UNITED STATES  
DEPARTMENT OF THE INTERIOR  
BUREAU OF LAND MANAGEMENT

FORM APPROVED  
OMB NO. 1004-0137  
Expires: January 31, 2018SUNDRY NOTICES AND REPORTS ON WELLS  
Do not use this form for proposals to drill or to re-enter an  
abandoned well. Use form 3160-3 (APD) for such proposals.

5. Lease Serial No.  
NMNM30400
6. If Indian, Allottee or Tribe Name
7. If Unit or CA/Agreement, Name and/or No.
8. Well Name and No.  
RED HILLS NORTH UNIT 213 ✓
9. API Well No.  
30-025-36584 ✓
10. Field and Pool or Exploratory Area  
RED HILLS
11. County or Parish, State  
LEA COUNTY, NM ✓

EOG Resources requests permission to plug this well using the attached procedure. The wellbore schematic is attached.

WELL NAME: *Red Hills North Unit 213 WIW*

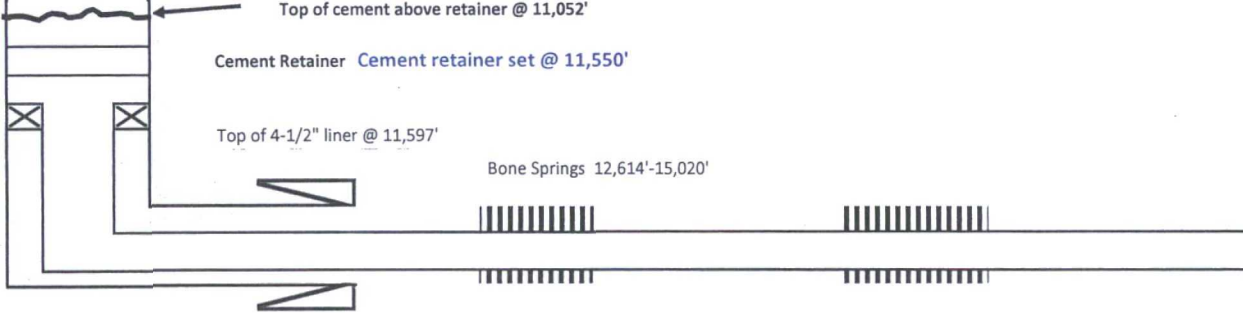
1. Well is currently TA'd but failed MIT test – this procedure is to fully P&A the RHNU #213H WIW
  - a. For TA, cement retainer set @ 11,550', and top of cement above cement retainer is @ 11,052'.
2. Spot 45 sx class H cement @ 9300-9086' (Bone Springs) *15 Add Spacer plug 7300-7130.*
3. Spot 25 sx class C cement @ 5250'-5130' (shoe) *98*
4. Perf and squeeze 45 sx class C @ 3850-3710. WOC and tag (bottom of salt)
5. Perf and squeeze 45 sx class C @ 1575-1455. WOC and tag (top of salt)
6. Perf and squeeze 45 sx class C @ 700-600. WOC and tag (shoe)
7. Perf and squeeze 85 sx class C @ 200-surface.
8. Cut off wellhead and weld on dry hole marker (below ground marker)
